SERVICE TECHNICAL INFORMATION

ONE POINT REPAIR

UTSUNOMIYA, JULY 15, 1997
 REF. NO.: S1-97-021
 CUSTOMER RELATIONS & SERVICE DIV.
 (Revised)

MODEL: LCX-50
 SUBJECT: Display does not operate
 CONTENTS: When repairing LCX-50, refer to both the contents below and the other relevant *Service Technical Information*. (Relevant *Service Technical Information*: G-95-16)

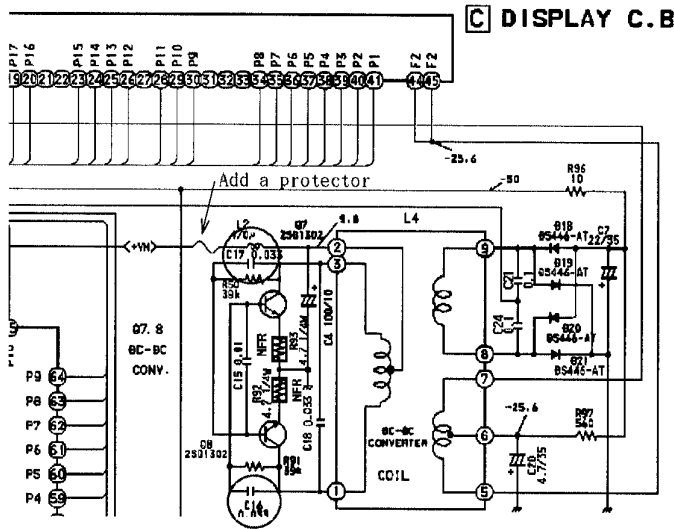
- REMEDY:
1. Remove the front board chip condenser. Attach a Mylar condenser to the bottom surface of the board. (Refer to the arrow mark in the figure below.)
 Ref. No. C16, 17 C-CAP 0.033 μ F \rightarrow Mylar CAP 0.033 μ F BK (material change)
 2. Cut the front board VM line pattern. Attach a protector to the bottom surface of the board.

Cut the pattern and add a protector.

Ref. No.	Part Name	Part No.
C 16, 17	CAP M 0. 033-50 J	88-700-840-810
—	PROTECTOR 630mA491	87-A90-560-080
